**University of Technology Sydney
Blackfriars Precinct Research Building Industry Hub
4-12 Buckland Street Chippendale NSW**

Response to Submissions

Section 4.55(2) Modification Application

**SSD 6746 Blackfriars Concept Development Proposal
UTS Blackfriars Precinct Research Building**

Figure 1 Aerial Photograph of the Grafton Street/Buckland Street Corner.

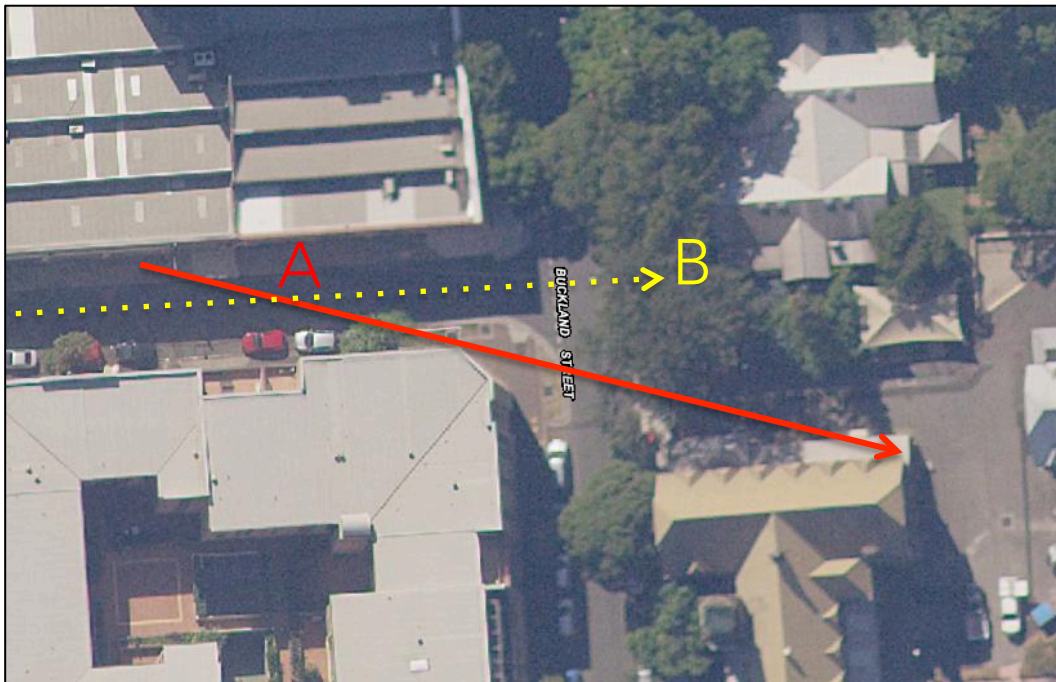
Council's submission notes concerns that the view of Grafton Street currently extends into the campus and incorporates the northern facade of Building CB22. This is inaccurate. Currently, the view along Grafton Street is terminated by the existing former one storey childcare building. Views of the northern facade of CB22, the former girls' school building, which does not align with Grafton Street, can only be seen from the far eastern end of Grafton Street as they are blocked by the residential flat building at 2 Grafton Street beyond about 20m west of the corner.

Position "A" shows the line along Grafton Street at which the northern façade of the former Girls' School CB22 first comes into view looking east (approximately 20m west of Buckland Street on the centreline). West of this line, CB22 is not visible.

Position "B" shows the alignment of Grafton Street is terminated by the former childcare centre building and its ancillary structures

The proposed modification will not reduce the available views of the northern façade of CB22, and will instead, as noted above, open a 16.7m wide space connecting Buckland Street with the heritage significant quadrangle space in the centre of the Blackfriars Site. The size and alignment of this space is in accordance with the current Concept Development Approval for the site, which responds to the alignment of the existing heritage buildings on the site. These significant setbacks will clearly allow meaningful vistas from the end of Grafton Street and from Buckland Street into and beyond the campus boundary.

Figure 2 2 Grafton St/23 Buckland Street – Living Room Windows

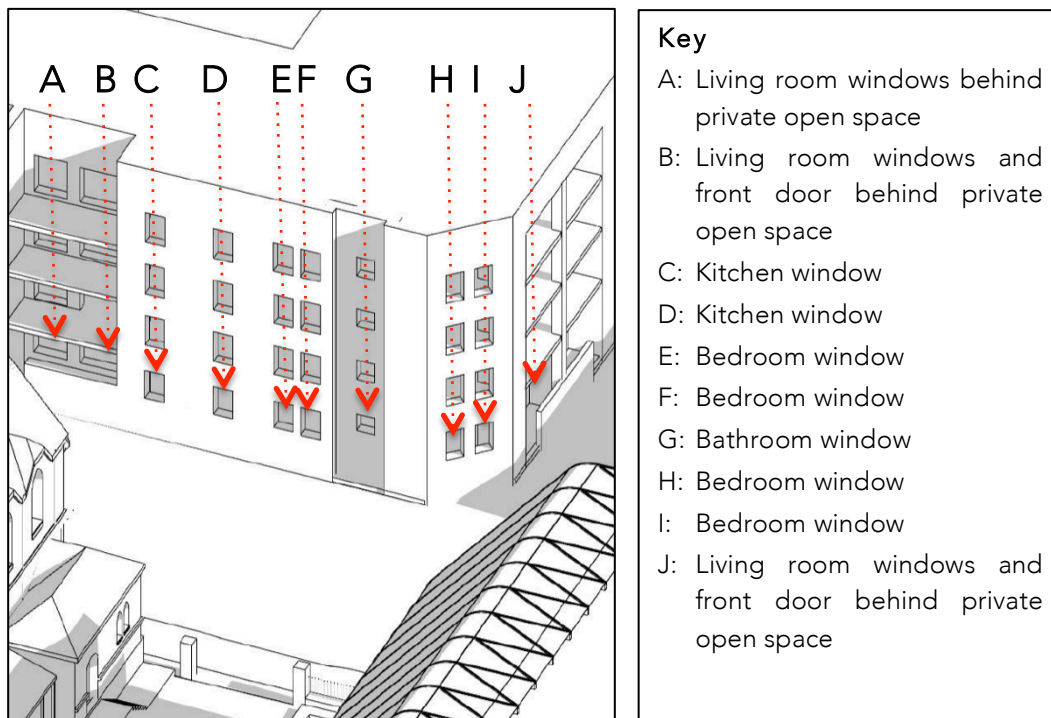
Council has raised a concern that the overshadowing information provided with the modification application is inadequate and it has questioned whether two hours solar access to 2 Grafton Street apartments is maintained. Council has also noted its position that solar access cannot be relied on to these apartments after 11.30 due to the orientation of Grafton Street – refer to Council's comments 1.d) at page 2 of its submission.

essential to understand which are the windows to living areas or private open spaces of the affected development as well as the extent of the shadow resulting from the proposed envelope. Figure 2 shows the uses behind the windows facing Buckland Street and Grafton Street. Only windows A, B, J are windows to living areas. In accordance with State policy, what needs to be assessed is whether these windows and the private open spaces in front of them have their solar access reduced to below two hours in midwinter by the envelope as proposed by the Modification.

UTS accepts Councils assertion that sunlight after 11.30 cannot be relied upon for windows on the Buckland Street elevation due to their orientation. This means that the two hours prior to 11.30am – ie from 9.30am to 11.30am in midwinter – is important in assessing whether any additional overshadowing from the proposed development as modified is acceptable.
